# Railyards Specific Plan Update, KP Medical Center, MLS Stadium, & Stormwater Outfall

Final Subsequent Environmental Impact Report

P15-040 | SCH No. 2006032058

October 2016

**Figure S-3**  
Illustrative Site Plan: KP Medical Center - Phase 2

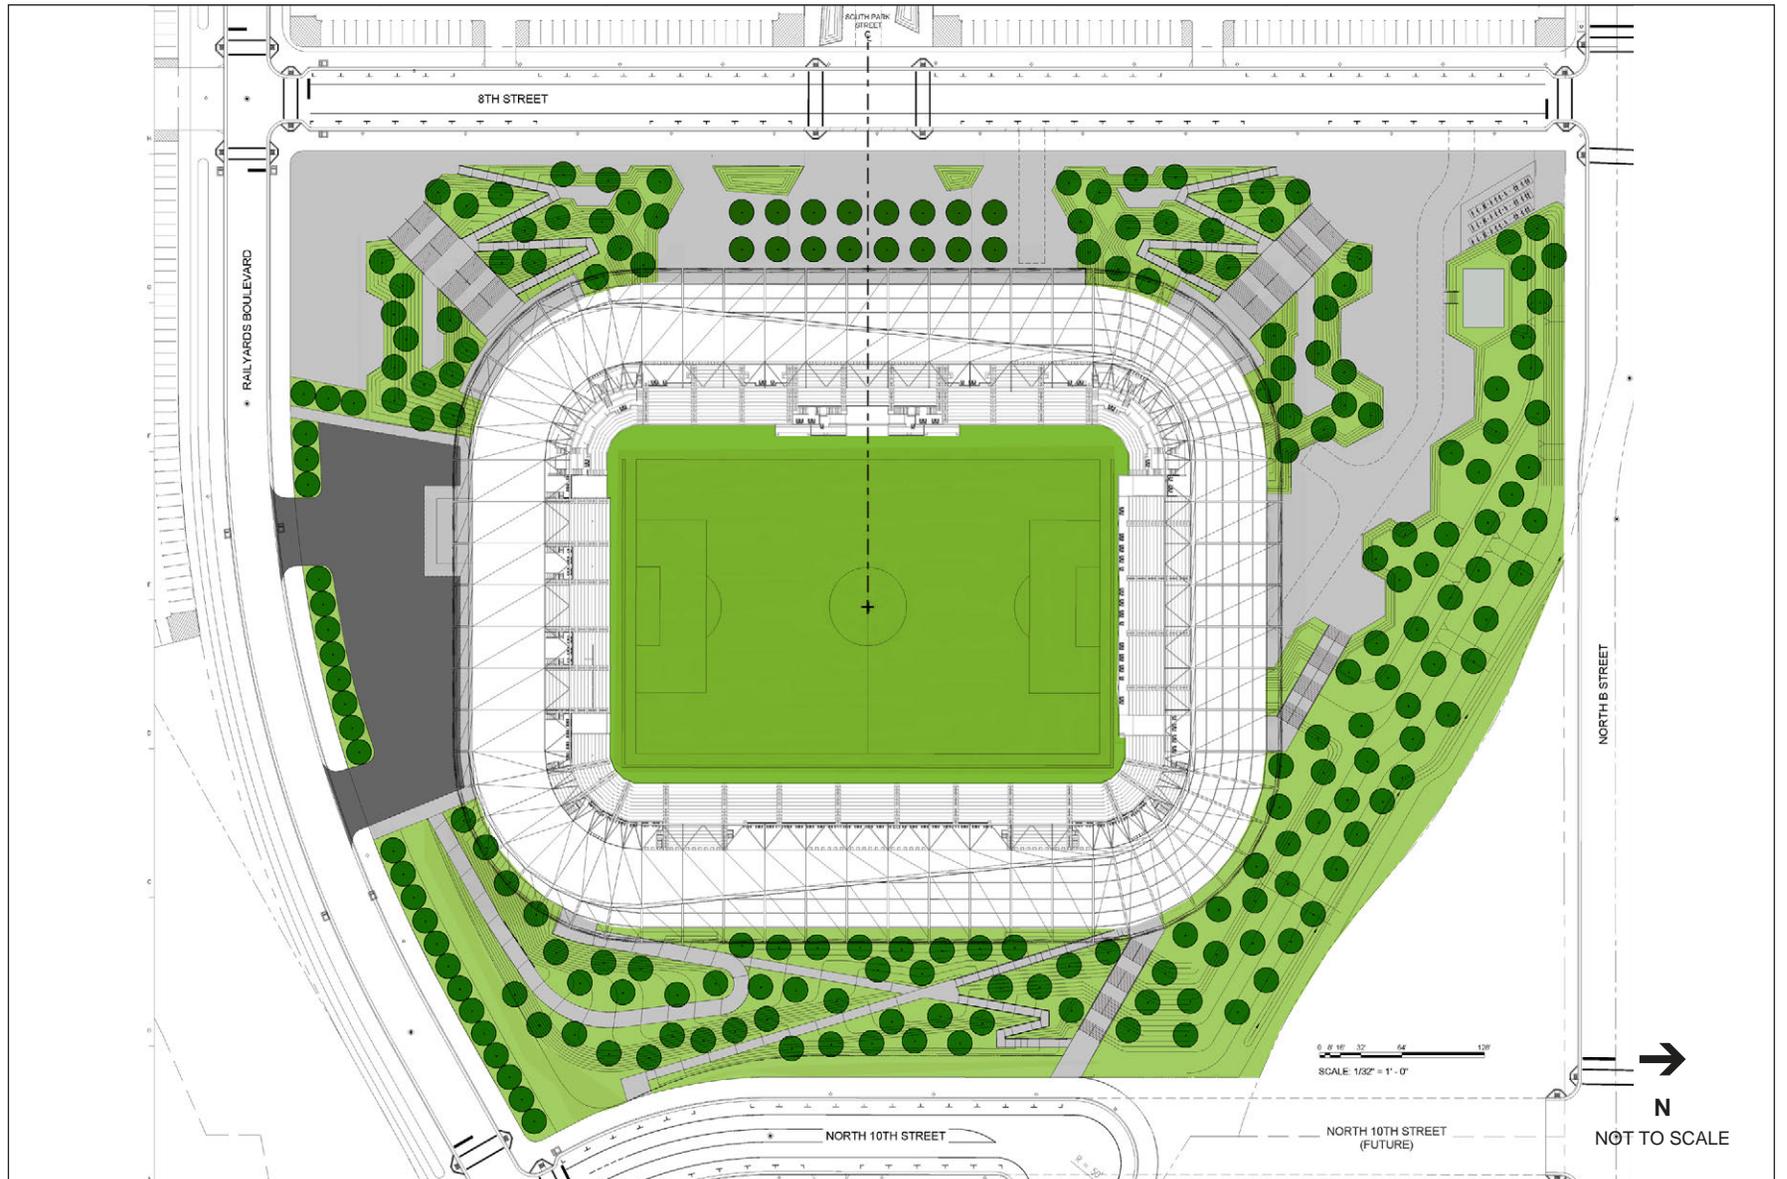
Figure S-3, Illustrative Site Plan: KP Medical Center - Phase 2, is revised to show the two potential helistop locations.

**Figure S-4**  
Major League Soccer Stadium Conceptual Site Plan

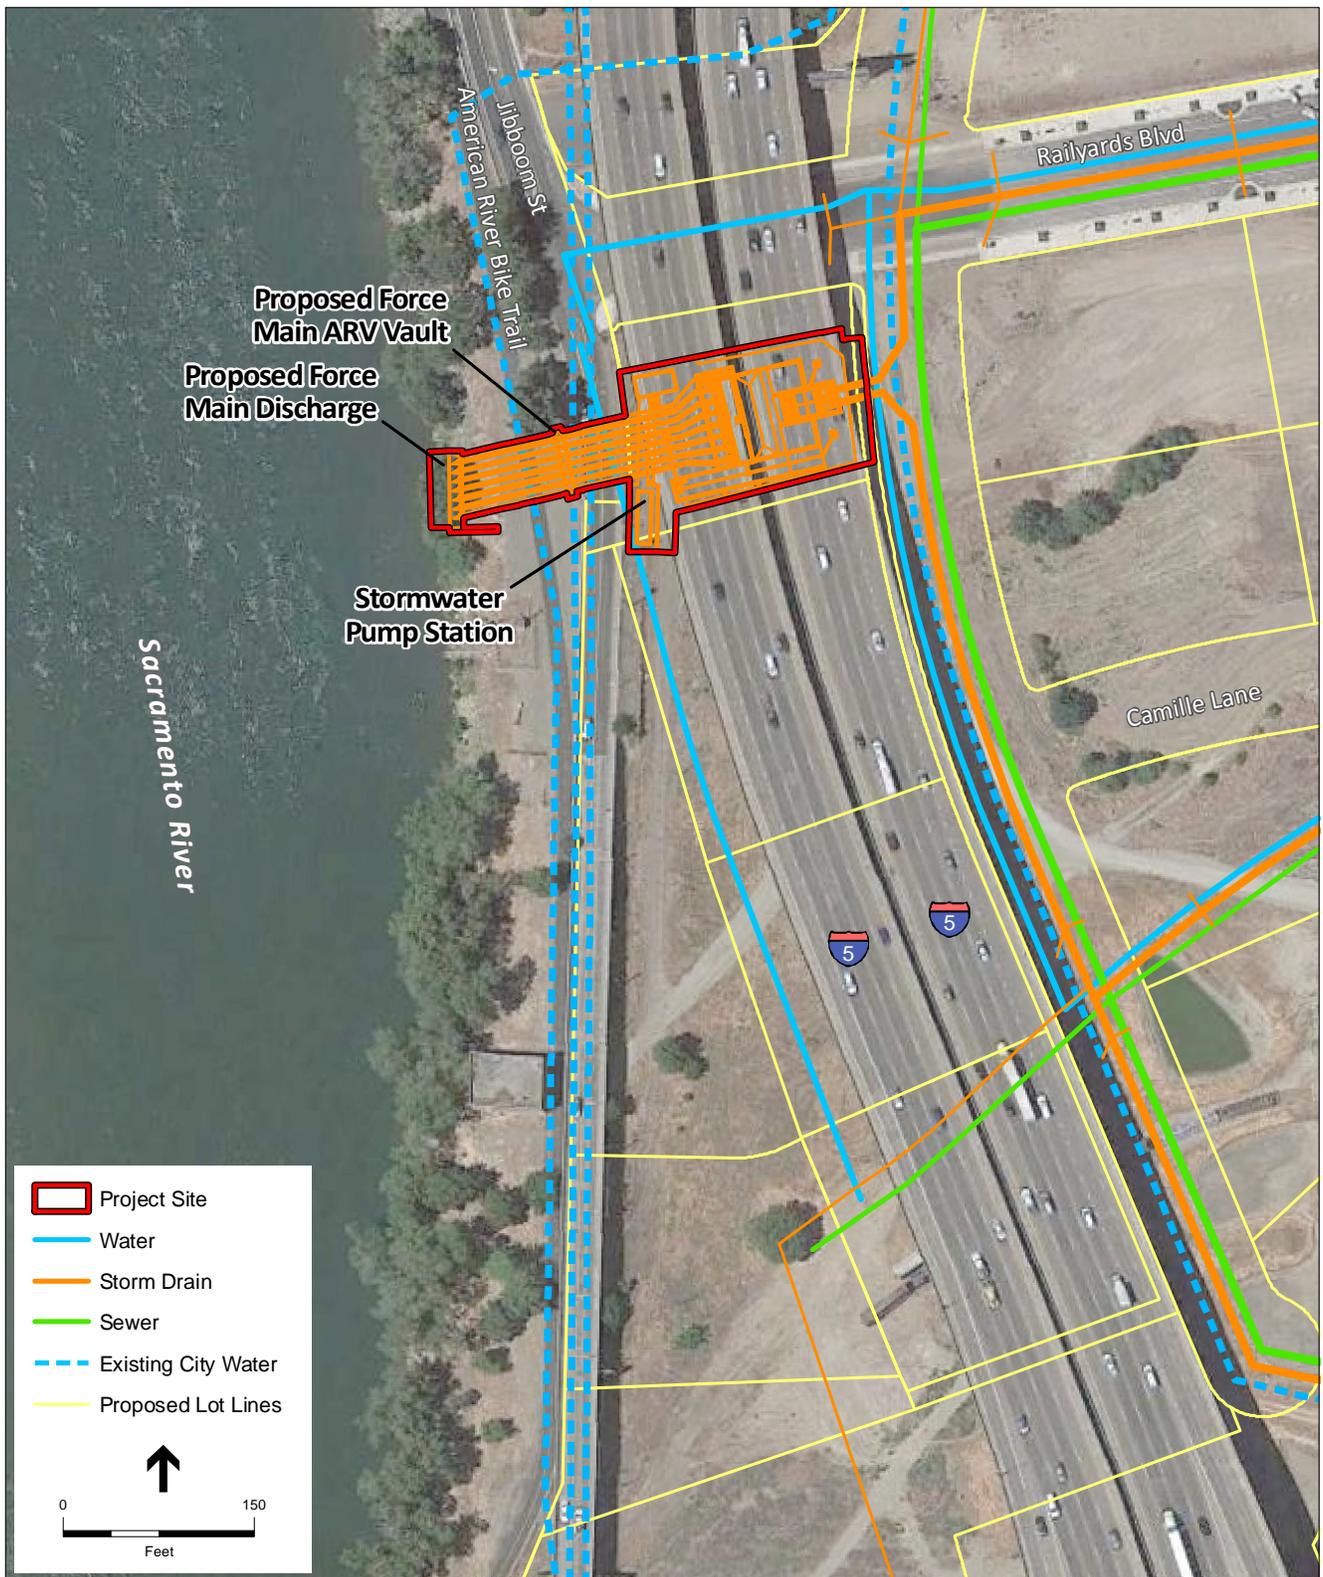
Figure S-4, Major League Soccer Stadium Conceptual Site Plan, is revised to show the revised MLS Stadium location moved approximately 40 feet to the north.

**Figure S-5**  
Pump Station and Outfall Site

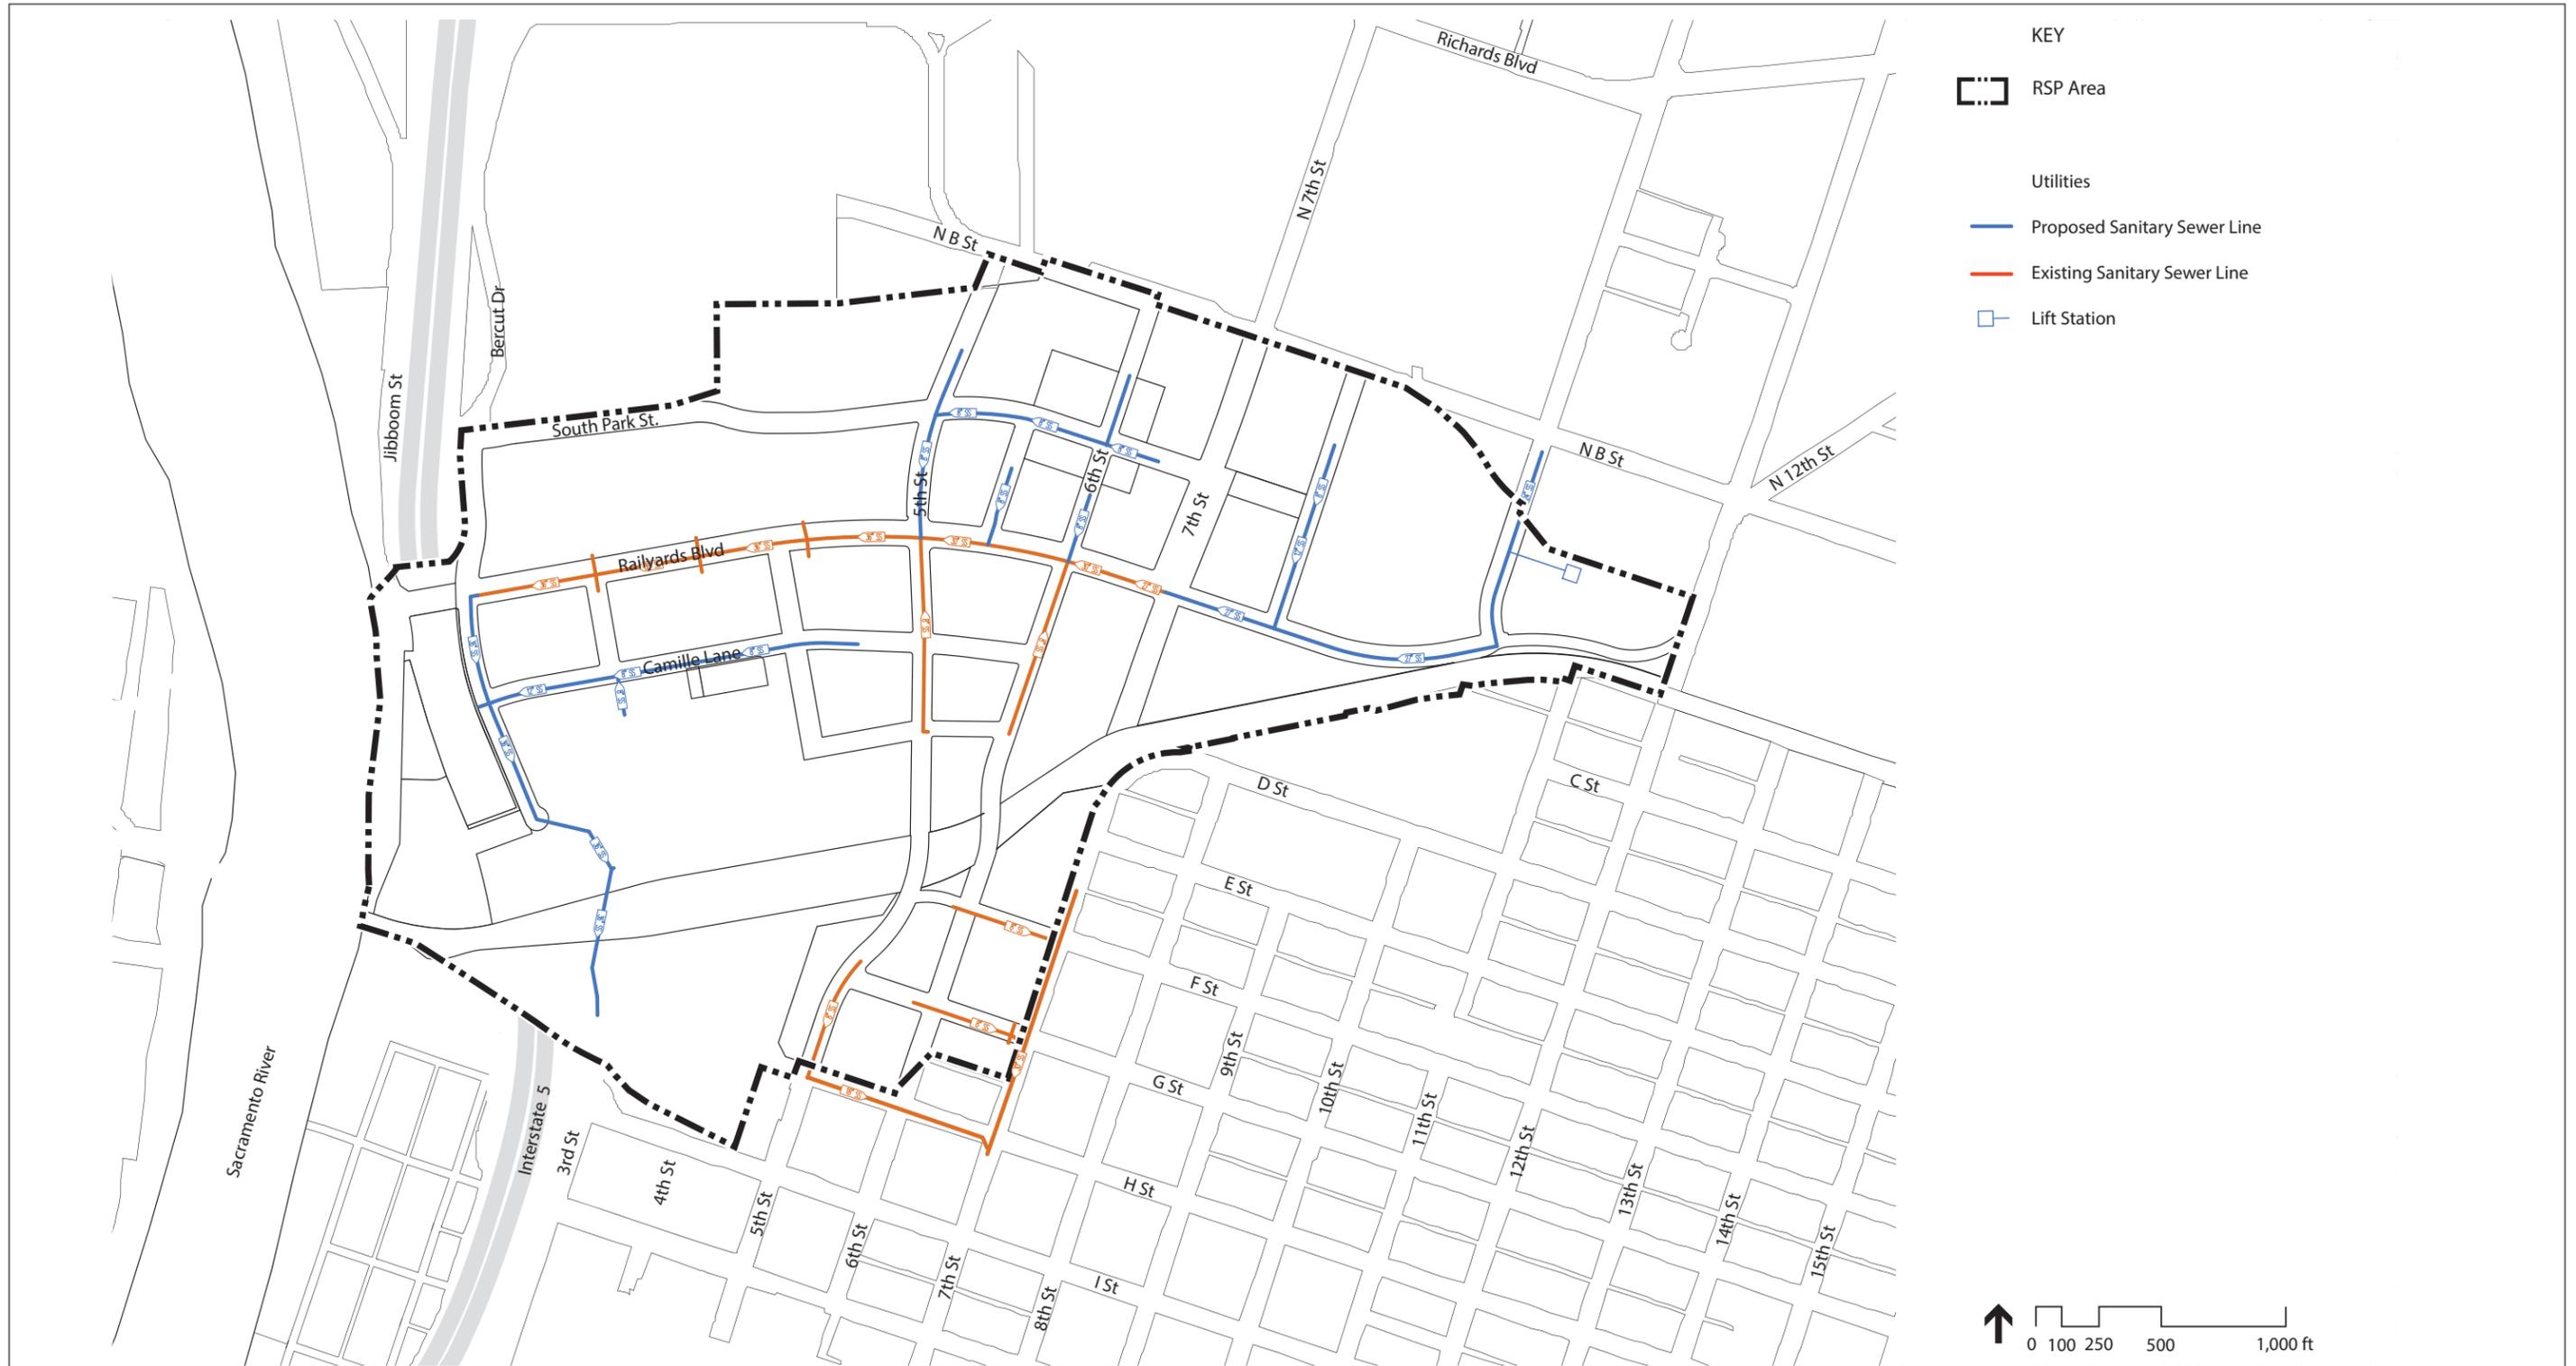
Figure S-5, Pump Station and Outfall Site, is revised to show revised pipelines connecting the pump station to the outfall structure.

**Figure 2-18**  
Utilities - Wastewater System

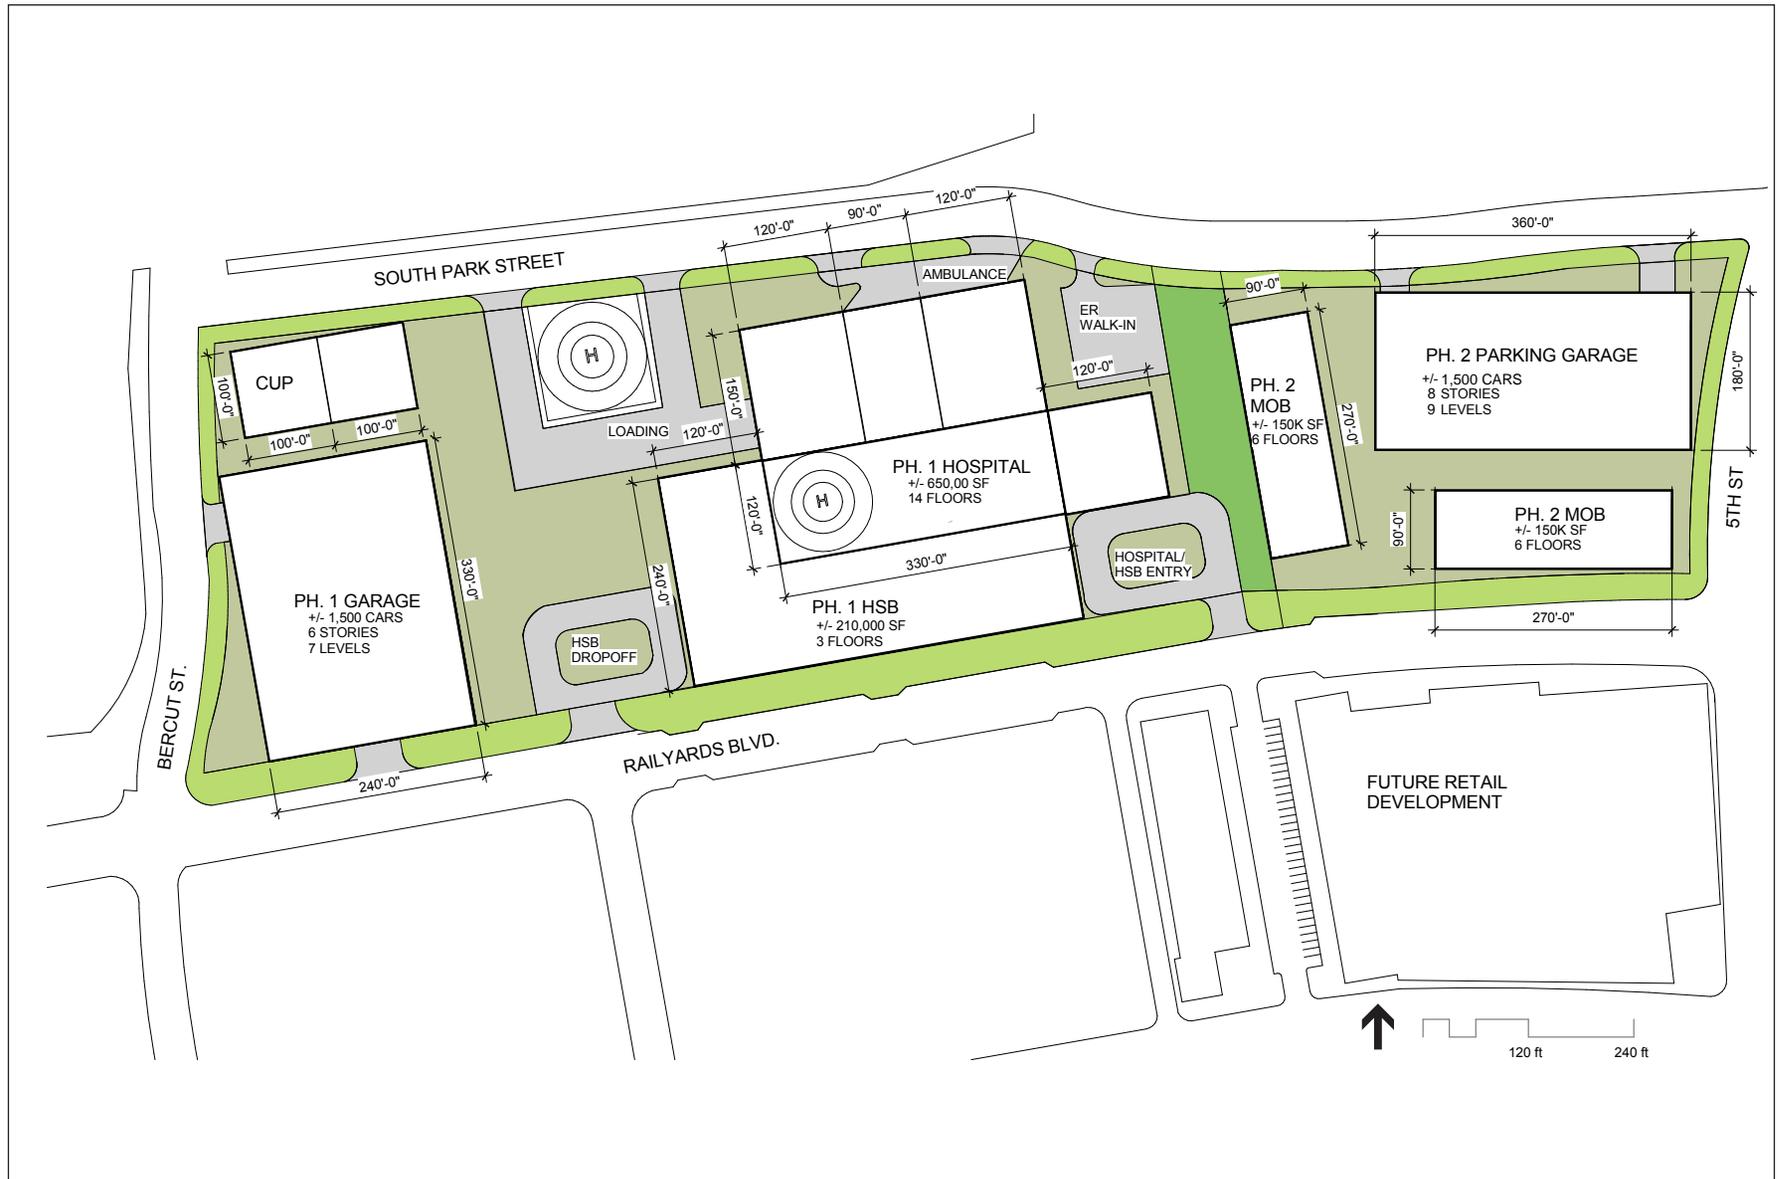
Figure 2-18, Utilities – Wastewater System, is revised to reflect a changed location for the future lift station. The lift station is conceptually anticipated to be constructed on Lot 51b, east of 10<sup>th</sup> Street.
